**SUBMITTAL TO THE BOARD OF SUPERVISORS  
COUNTY OF RIVERSIDE, STATE OF CALIFORNIA**

**ITEM: 3.45  
(ID # 20747)**

**SUBJECT:** TRANSPORTATION AND LAND MANAGEMENT AGENCY/TRANSPORTATION:  
Introduction of Ordinance No. 461.11, Amending Riverside County Ordinance No. 461 Relating to the County Road Standards and County Standard Specifications. CEQA Exempt per State CEQA Guidelines section 15061(b)(3). All Districts. [\$0]

**BUS TURNOUT**

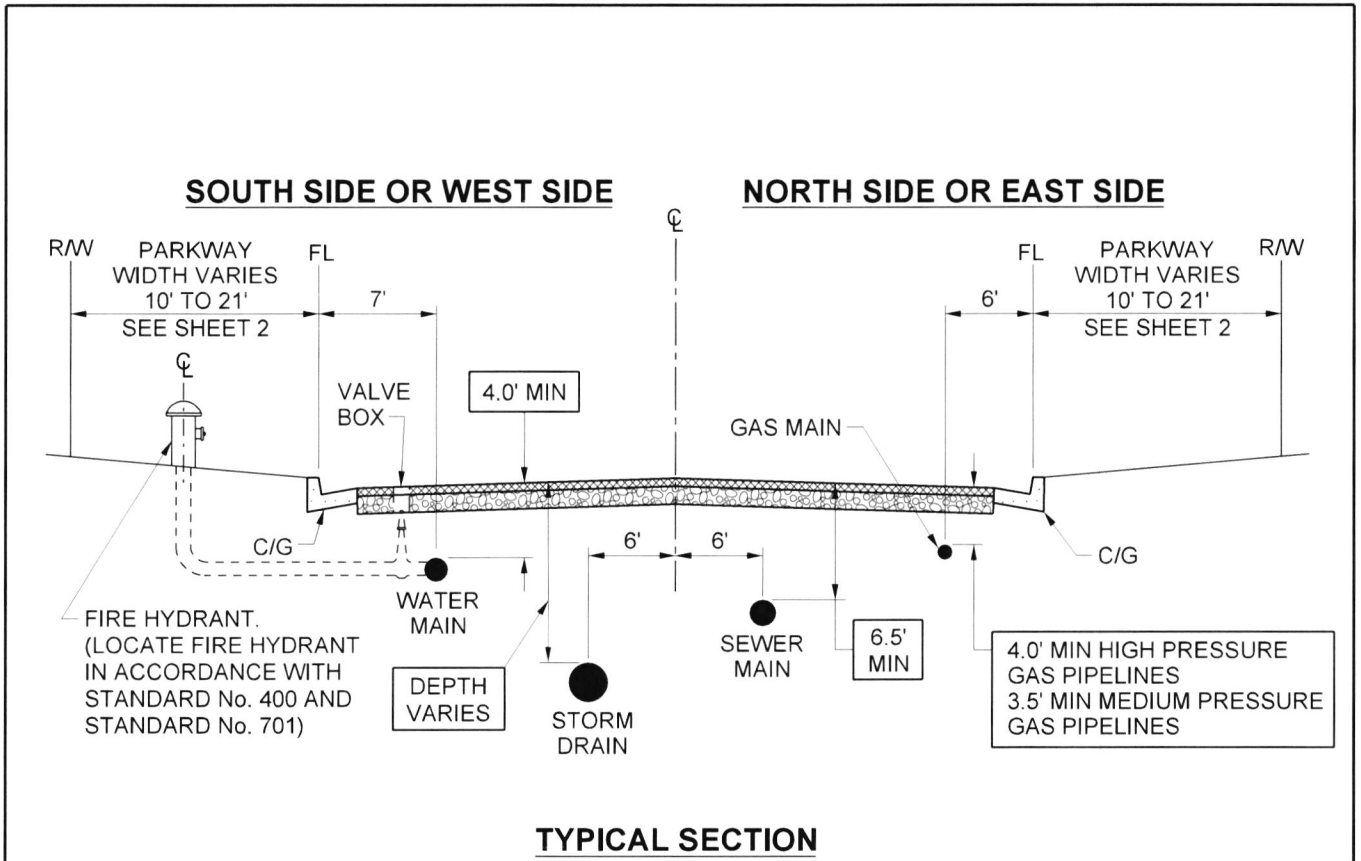
Page No. in 2007 Riv Co Road Stds PDF	Std No.	Ordinance No. 461.10 (2007) Road Std Title	Ordinance No. 461.11 (NEW) Road Std Title	Deleted Standard	Added New Standard	Combined or Split Sheets	Applied Revised Border, Title Block	Reformatted Drafting	Modified Title of Standard	Updated Accessibility (ADA) Compliance	Removed Plastic Sheeting (See Std 401)	Added Subgrade Compaction Note	Updated Soil Note	Modified/Added Concrete Specification	Modified the Notes Section	Other Changes to Text, Details	Additional Notes / Comments
			<b>806</b> Entry Street 50' Imp / 80' R/W		X												Added new standard.
114	<b>810</b>	Barricade					X	X									Added note to meet Caltrans requirements.
115	<b>812</b>	Multiple Mailbox Installation for New Sidewalk					X	X							X	X	Modified geometry of sidewalk around mailbox.
116	<b>813</b>	Multiple Mailbox Installation for Existing Sidewalk					X	X							X	X	
117	<b>814</b>	Bus Turnout					X	X		X			X		X	X

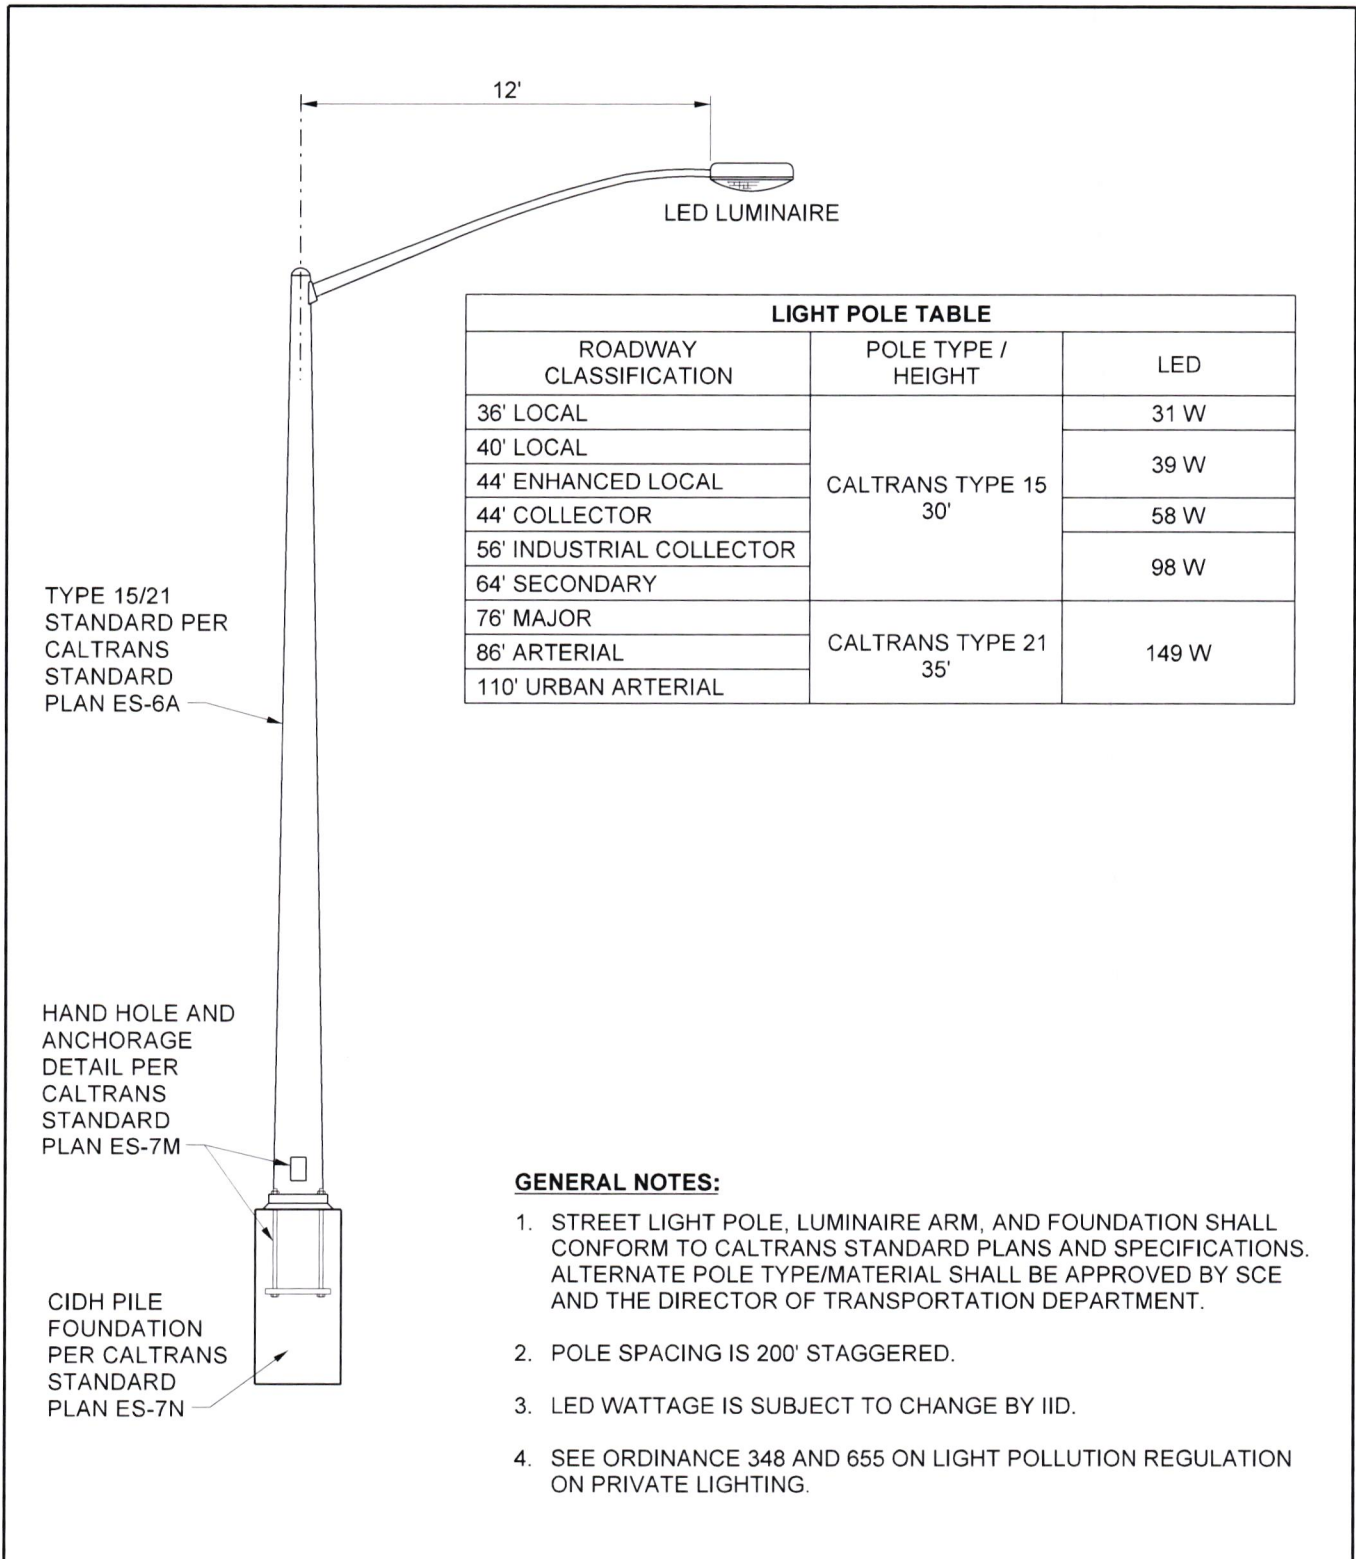
1. Changed the type of street lights from High Pressure Sodium Vapor (HPSV) to Light-Emitting Diode (LED) to utilize latest technologies in the reduction of energy consumption costs. Added a street light standard for the Imperial Irrigation District service area.

128	<b>903</b>	Type "B" Monument					X	X									
129	1000	Residential Lighting	<b>1000-1</b> Street Lighting (Southern California Edison (SCE) Electric Serving Area)			X	X	X	X						X	X	Changed luminaire from HPSV to LED. Added tables. Updated notes.
			<b>1000-2</b> Street Lighting (Imperial Irrigation District (IID) Electric Serving Area)		X												Added new standard for street lights in Imperial Irrigation District service area.
			<b>1000-3</b> Street Lighting		X												Added details for sidewalk location around street lights.
130	1001	Arterial Highway Lighting		X													Deleted this standard. Combined information into Std 1000-1.
131	<b>1101</b>	Tree Setbacks at Corner Cut-Backs and Driveways					X	X									
			<b>1102</b> Tree Staking Detail		X												
			<b>1103</b> Backflow Prevention Device Installation		X												Added new landscaping standards.
132	<b>1200</b>	Traffic Signal Pole IISNS Straight Arm Mounting Detail	IISNS Mast Arm Detail				X	X	X						X	X	Modified dimensions.
